B. **VARIANCE REQUEST, MONSIGNOR ZOUHAIR TOMA KAJBOU, 2442 E. BIG BEAVER ROAD, ST. JOSEPH CHALDEAN CATHOLIC CHURCH –**

In order to construct an addition to the church and a new driveway: 1) An 8 foot variance from the requirement that the addition be set back 50 feet from the west property line, 2) a 43 foot variance from the requirement that the proposed driveway be set back at least 50 feet from the west property line, and 3) a variance from the requirement that a landscaped berm be provided between the proposed driveway and the west property line.

Preliminary Site Plan For City of Troy, Michigan

Applicant:	Monsignor Zouhair Toma Kajbou
Project Name:	St. Joseph Chaldean Catholic Church Renovations
Plan Date:	Submitted to Troy Planning Department December 3, 2010
Location:	2442 East Big Beaver Road
Zoning:	R1-E and RM-1
Action Requested:	Preliminary Site Plan Approval
Required Information:	Deficiencies noted

SHEET TITLE: **PRELIMINARY LANDSCAPE PLAN**
PROJECT TITLE: **ST. JOSEPH CHALDEAN CATHOLIC CHURCH**
2440-44 EAST BIG BEAVER ROAD
NW 1/4 OF SEC. 25, T.2N., R.11E.
CITY OF TROY, OAKLAND COUNTY, MICHIGAN

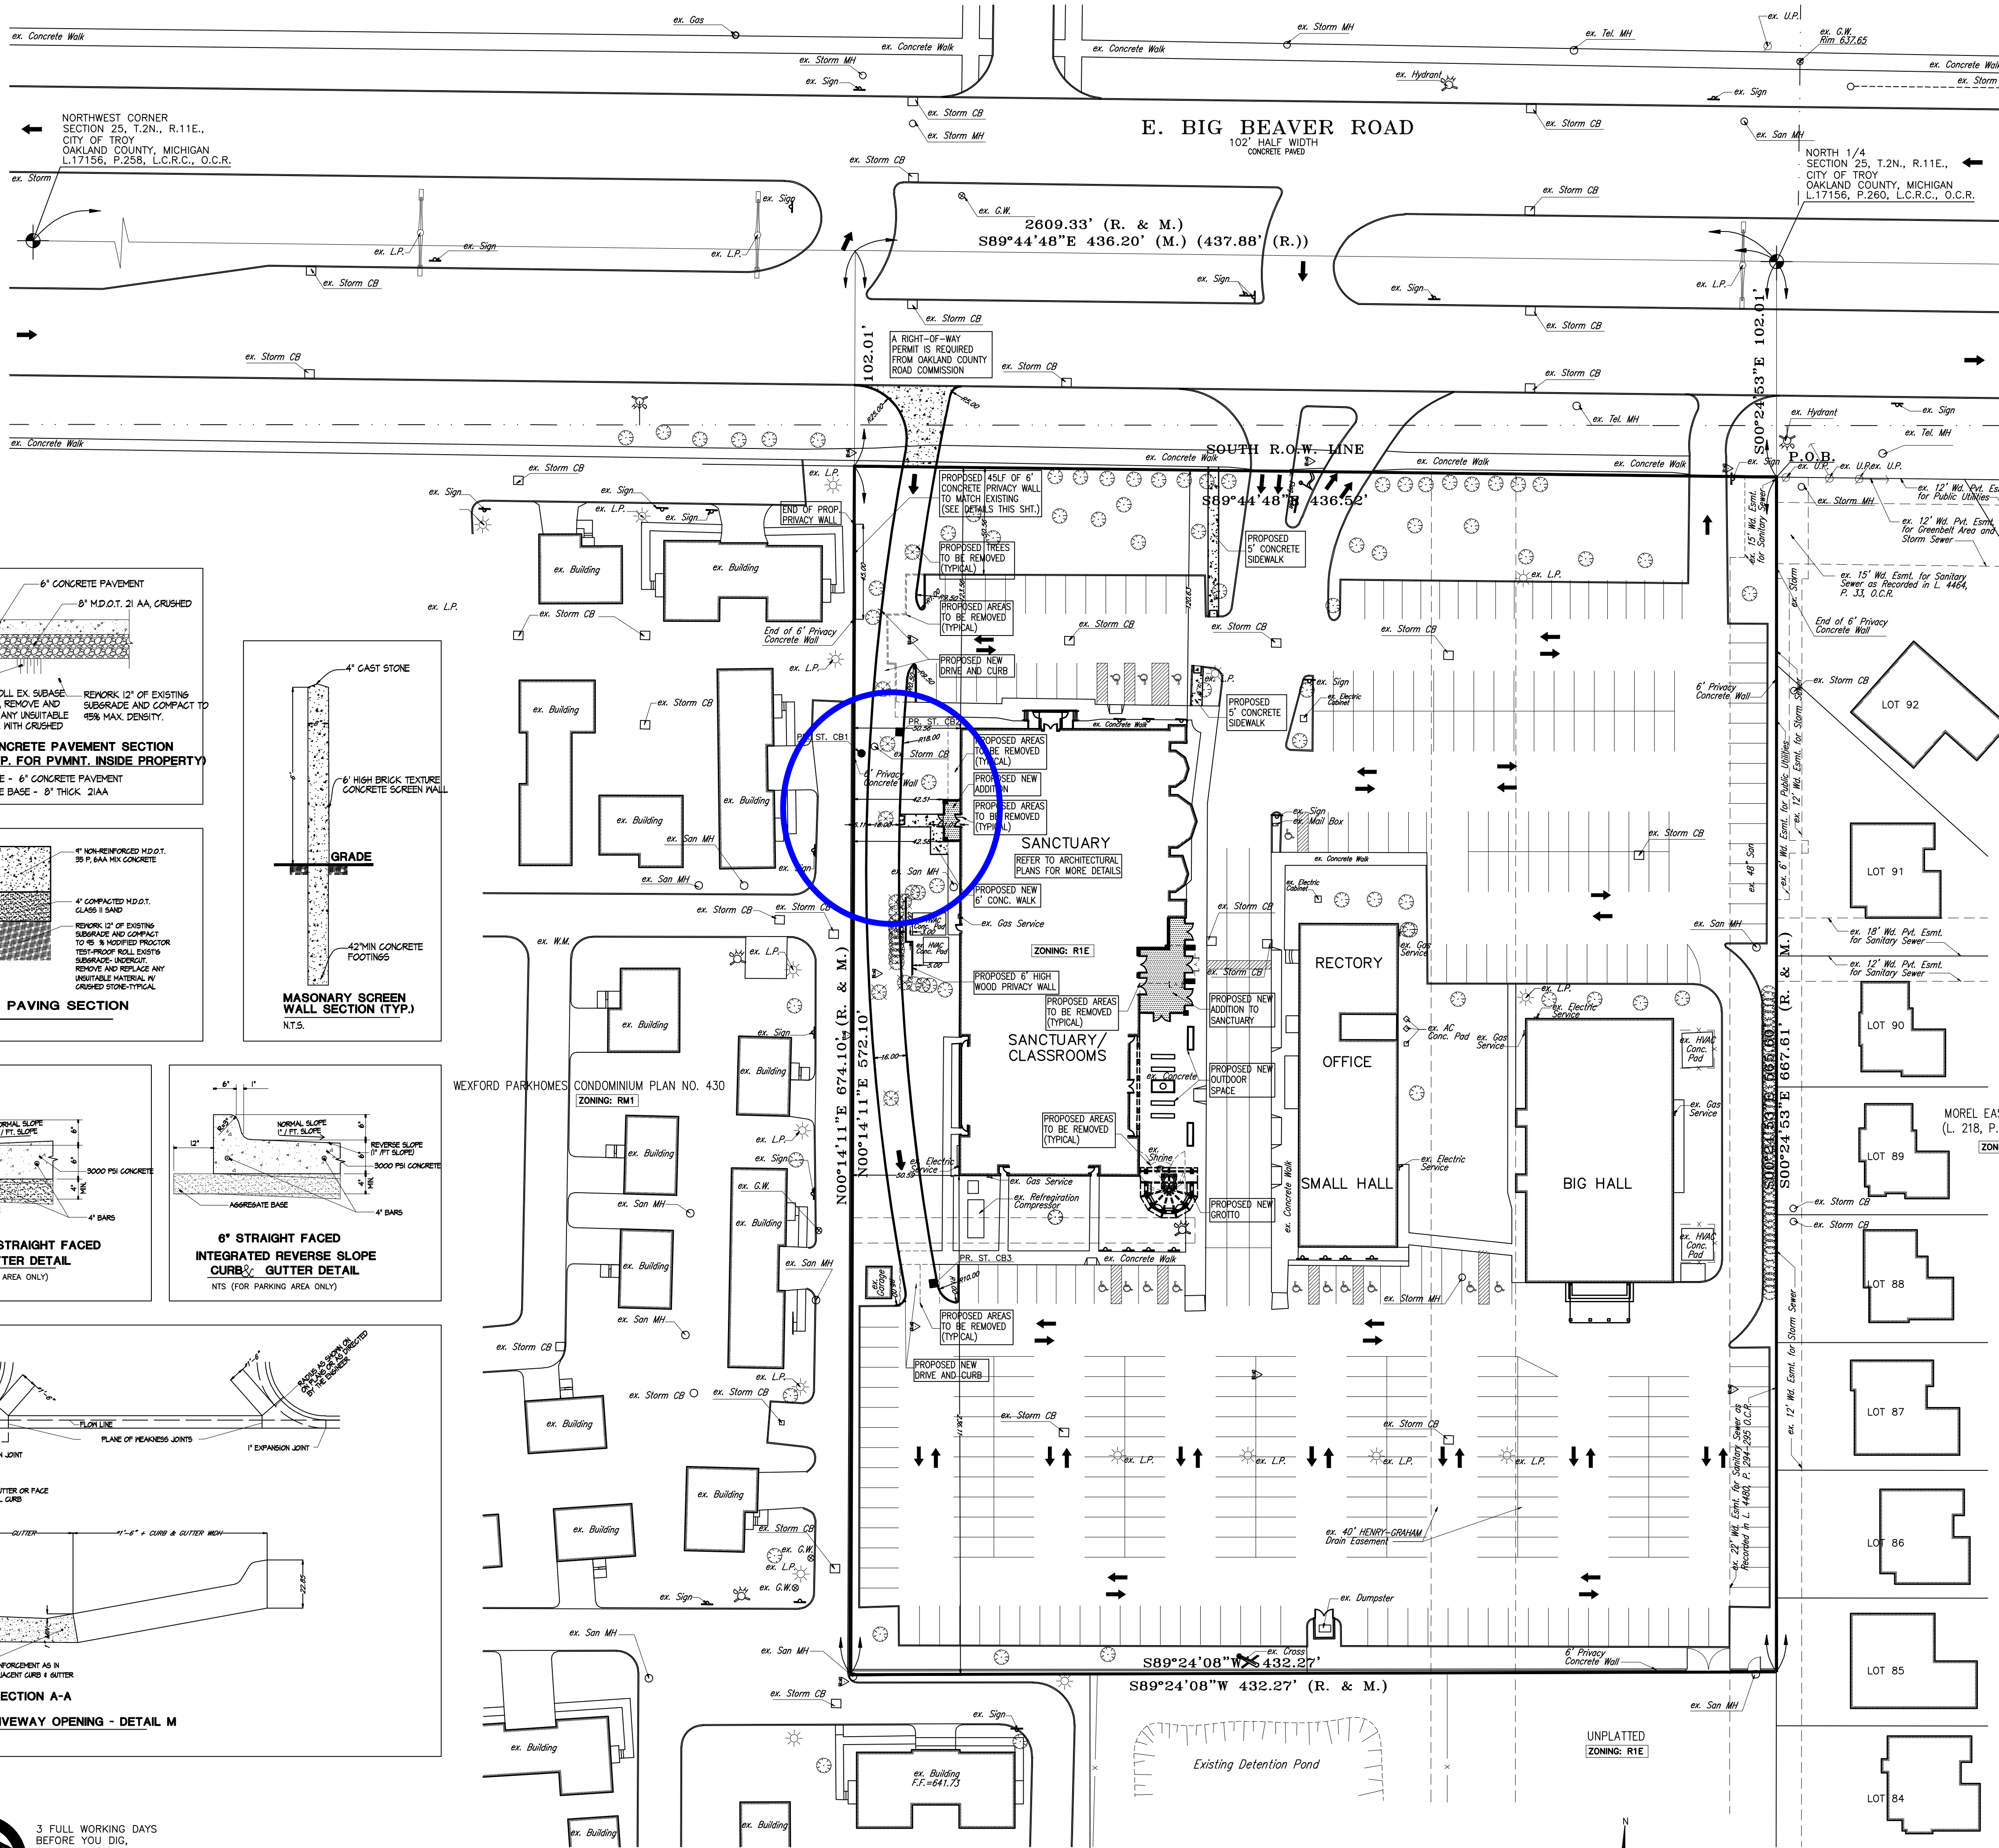
A landscape plan has been submitted, however it does not provide landscaping that takes into account the status of this project as a project requiring special use approval and does not take into consideration the specific use standards for churches.

Items to be Addressed: Provide revised landscaping to comply with Ordinance requirements if a variance is obtained.

NORTH
SITE PLAN
SCALE: 1" = 30'-0"

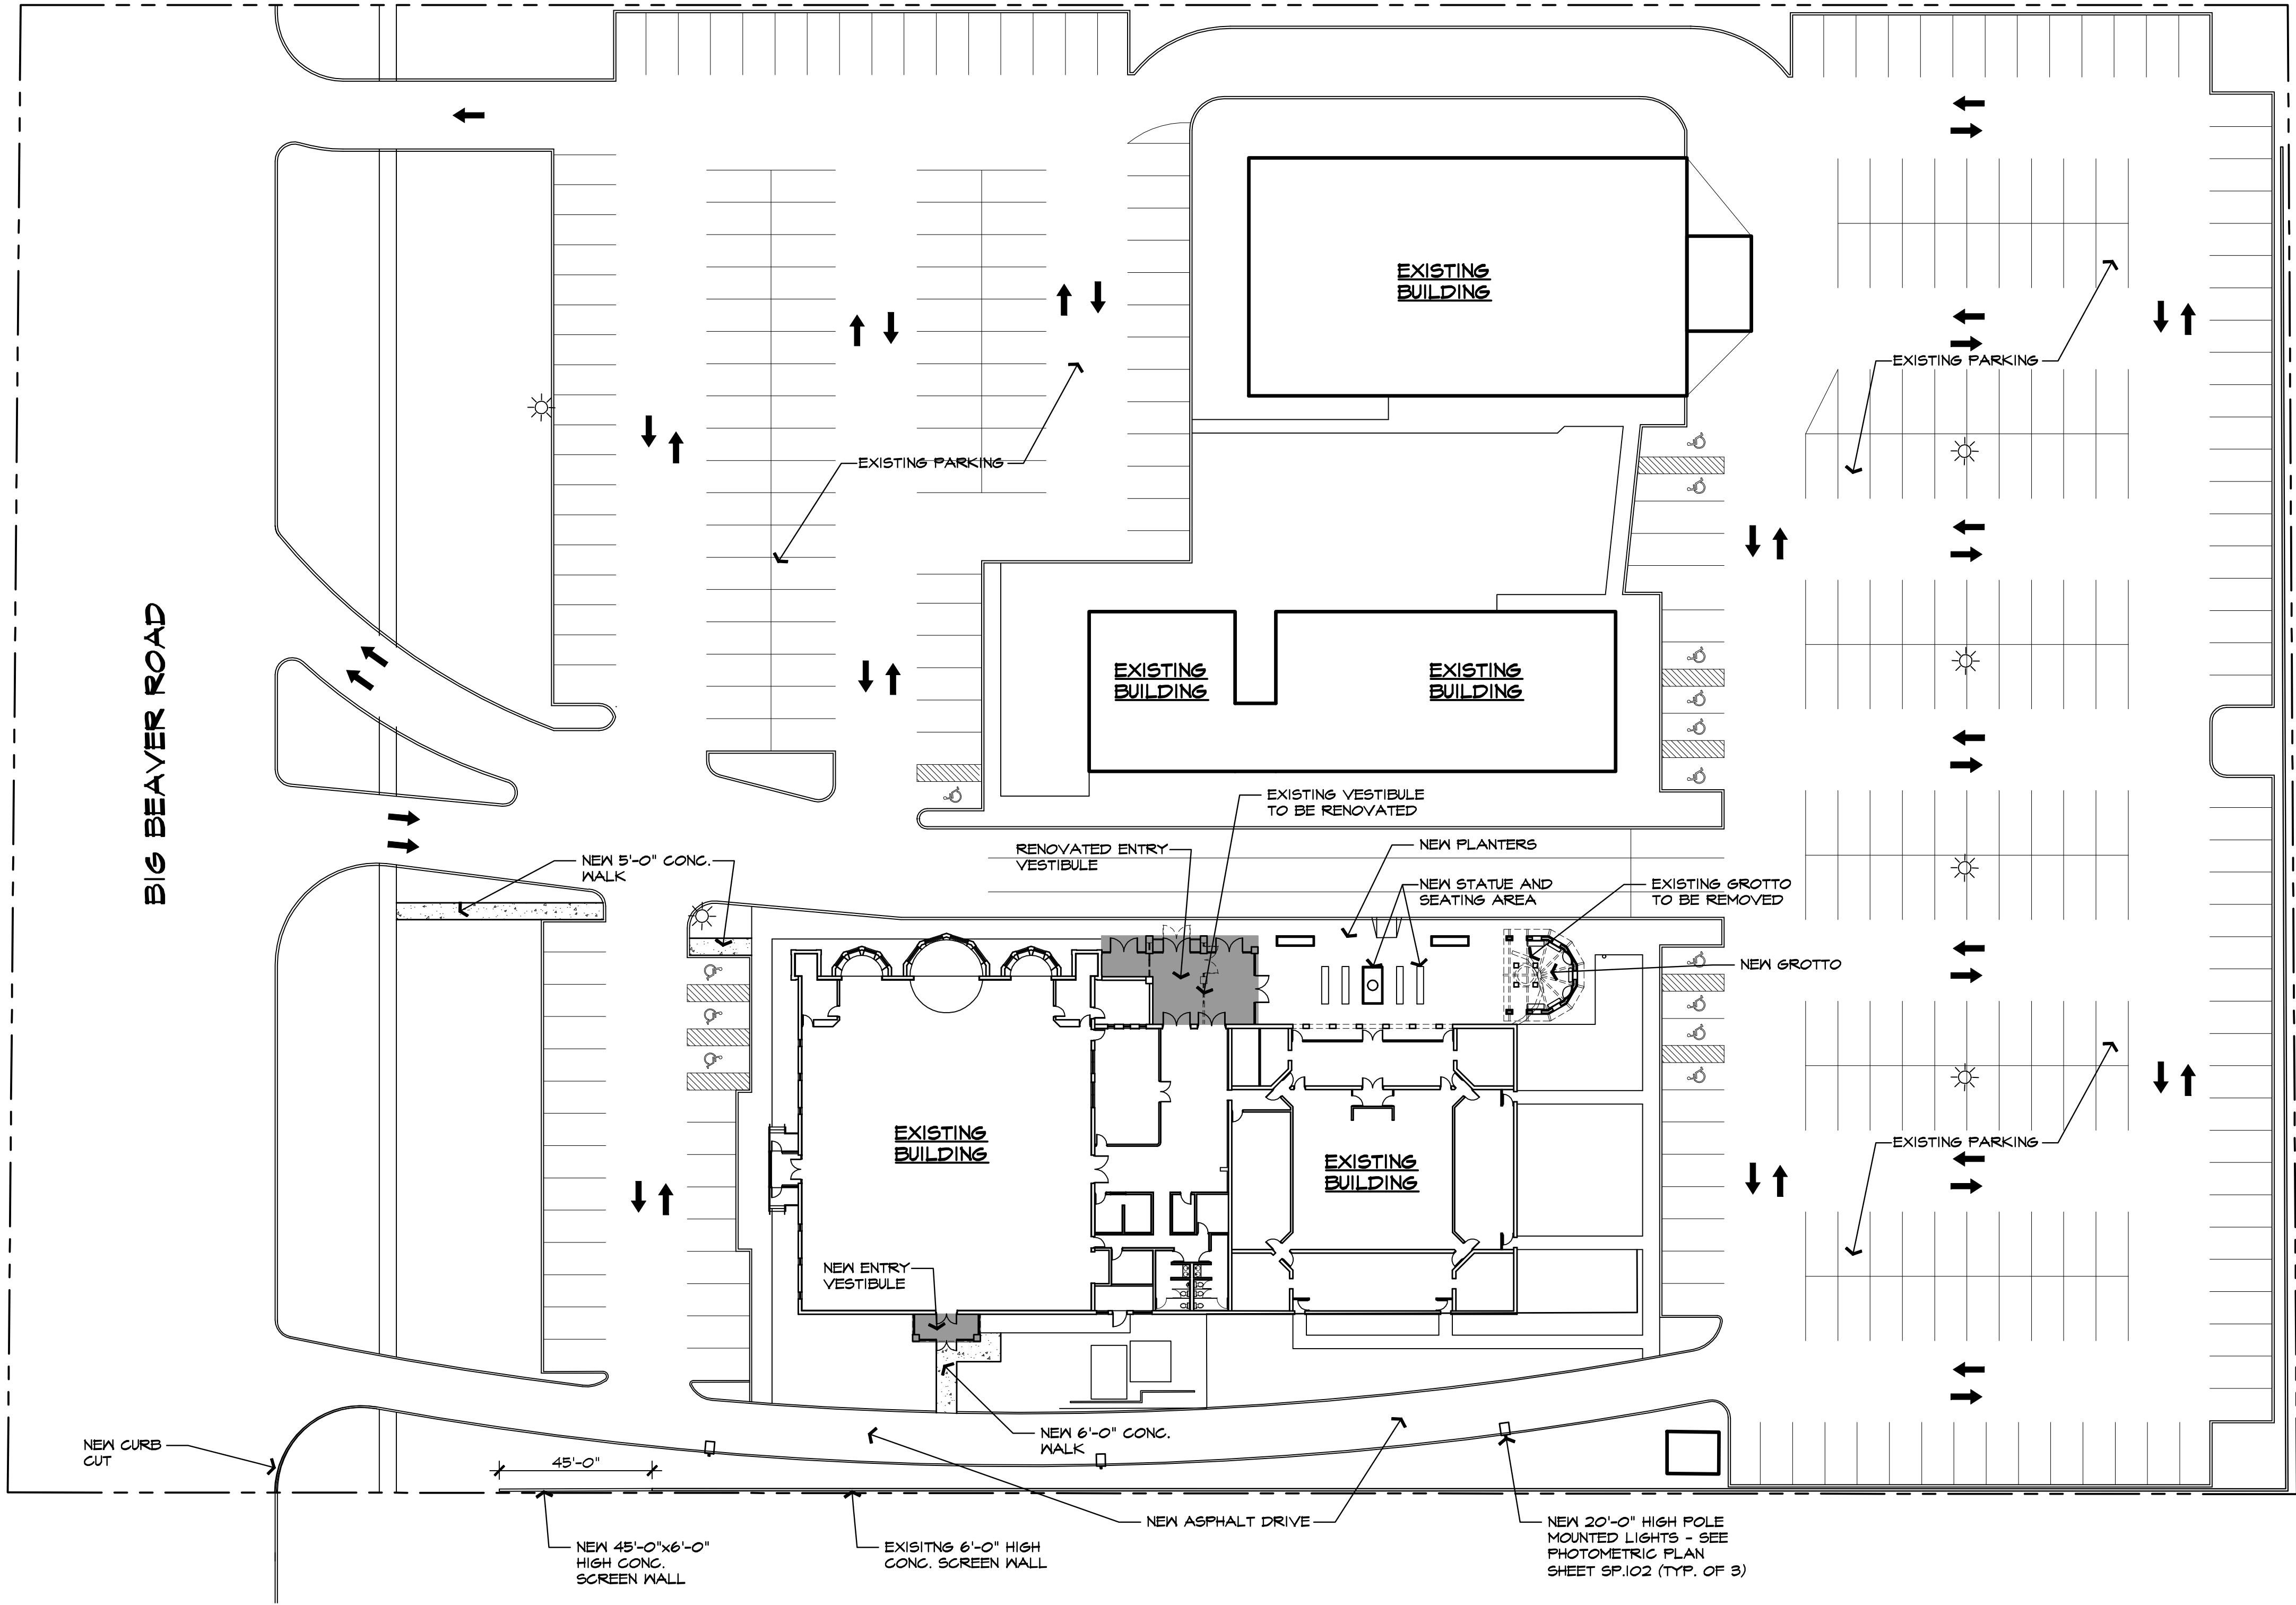
1. The proposed vestibule relates to subsection E, which states that there shall be a minimum of a 50'-0" side yard setback. The proposed vestibule area will encroach on the setback by approximately 7'-6", which we are asking for a variance on. This new vestibule area would serve as a covered area for the rear entry door.

2. The proposed drive relates to subsection F, which states that the side yard area abutting a residential district will be maintained as open landscaped area. The proposed new drive will violate this part of the ordinance, which we are asking for a variance on. The new drive will conform to the landscape requirements set forth in the zoning ordinance. This drive will alleviate the congestion and traffic on Big Beaver because it will become a second entrance to the site. The current entrance has a drop off area which tends to create backups onto Big Beaver. The new drive does not have a drop off area and will be a straight access to the parking lot at the rear of the site.

The site is accessed via two existing driveways. The plan would add a third at the extreme west end of the property. We do not necessarily oppose the third driveway, and defer to the City engineer in this regard. However, as noted elsewhere in this review the significant drive, vestibule, and drop-ff area in the required landscaped setback along the west side of the building violates the Ordinance and must be removed or a variance must be obtained to allow it to proceed.

Items to be Addressed: 1.) Remove west driveway and improvements on west side of building or obtain variance to allow development in the setback. 2.) Provide sidewalk connection to the main road sidewalks.
